No: 000255

Send To: 902 LOWER WING KIT

U
S
TSubject: CLARIFICATION OF WOOD
GRAIN DESCRIPTION IN
PREVIOUS PRODUCT LETTER
000252 DATED 02-16-82

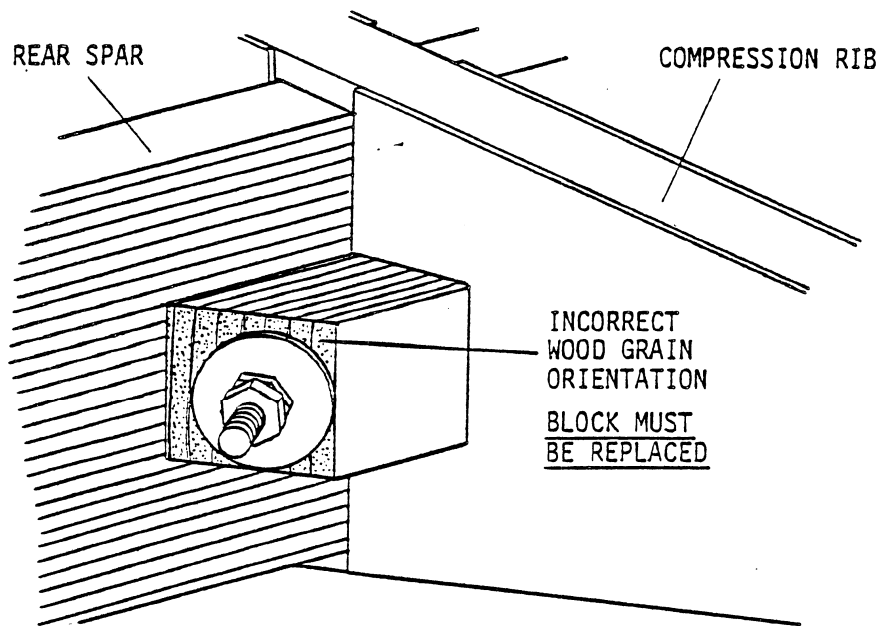
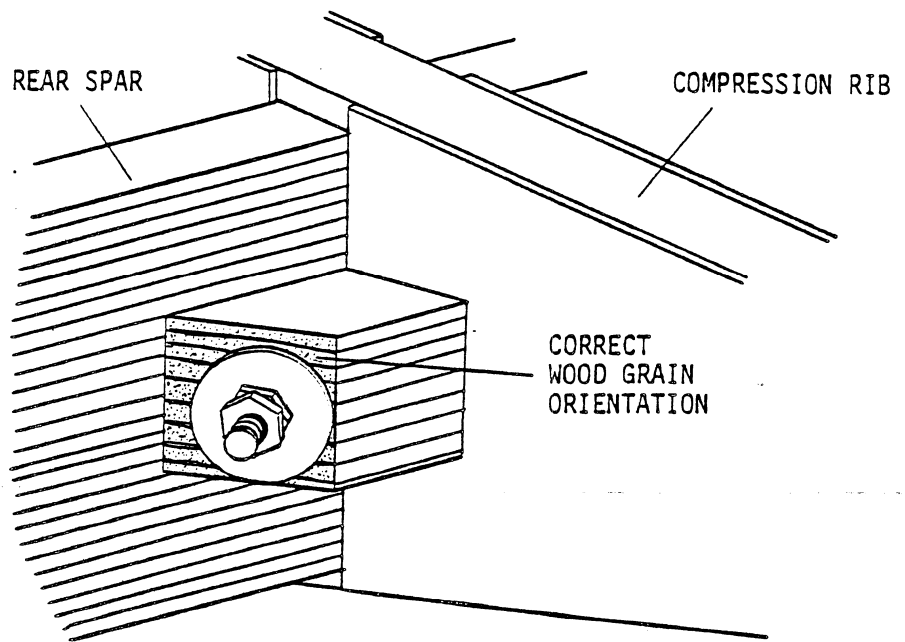
The subject product letter requested inspection of the direction of wood grain on the tierod blocks located on the rear spars of the upper and lower wings of the Eagle II aircraft. The phrase "perpendicular to the spar face" has caused much confusion. In response to many telephone calls requesting clarification of the grain direction requirement we have prepared Engineering Sketch X-90147 which illustrates the correct and incorrect grain directions.

It is unlikely that any blocks with incorrect grain were supplied to any Eagle builder, but one incorrect block was found on a Christen factory demonstrator aircraft, and this requires that inspection of the blocks be performed on all kits and completed aircraft.
